SOLICITATION AMENDMENT

Title - Sujet 8.3-8.6m.Hydro Survey Workboats	
Solicitation No. - N° de l'invitation F7047-150011/B	Amendment No. - N° modif. 002
Client Reference No. - N° de référence du client F7047-150011	Date 2016-03-15
GETS Reference No. - N° de référence de SEAG PW-\$\$MC-024-25684	
File No. - N° de dossier 024mc.F7047-150011	CCC No./N° CCC - FMS No./N° VME
Solicitation Closes - L'invitation prend fin at - à 02:00 PM on - le 2016-03-31	Time Zone Fuseau horaire Eastern Daylight Saving Time EDT
F.O.B. - F.A.B. Plant-Usine: <input type="checkbox"/> Destination: <input checked="" type="checkbox"/> Other-Autre: <input type="checkbox"/>	
Address Enquiries to: - Adresser toutes questions à: Pilon, Chantal	Buyer Id - Id de l'acheteur 024mc
Telephone No. - N° de téléphone (819) 956-4308 ()	FAX No. - N° de FAX () -
Destination - of Goods, Services, and Construction: Destination - des biens, services et construction: See herein

Bidder's Questions and Canada Responses

REQUIREMENT: SEVEN (7) 8.3 TO 8.6M ALUMINUM WORKBOAT WITH TRAILERS FOR THE DEPARTMENT OF FISHERIES AND OCEANS

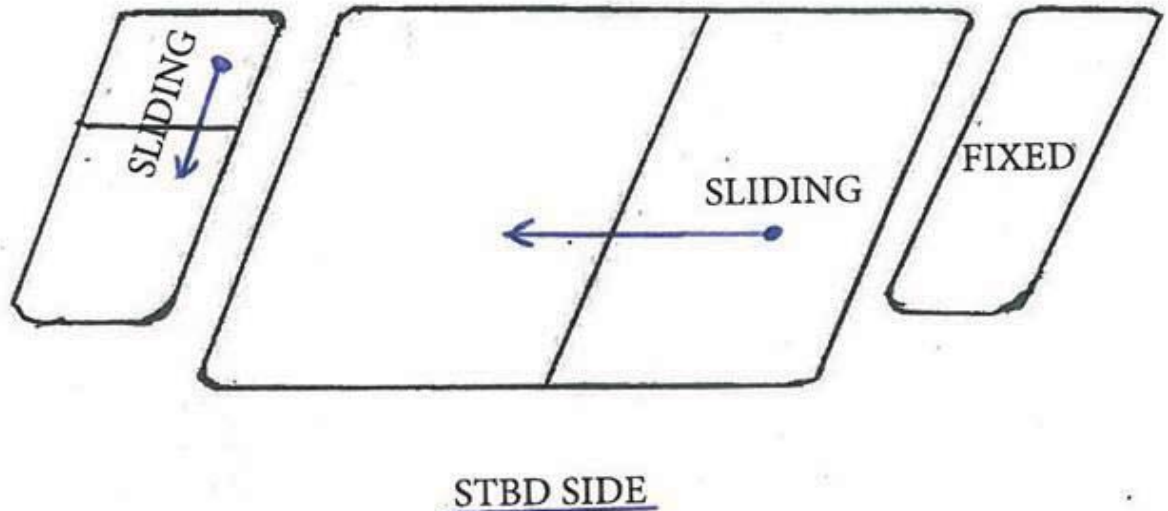
Question 11:

Reference 5.2.5.2, "Two (2) fixed side windows, in way of operator position". Can you confirm this is correct? Normally the operator requires an opening window to converse with crew on deck or shoreside dock.

Answer: 5.2.5.2 should have stated "Two (2) fixed side windows, one forward of the operator position and a second mirrored to the port side", please refer to window concept sketch provided in the TSOR.
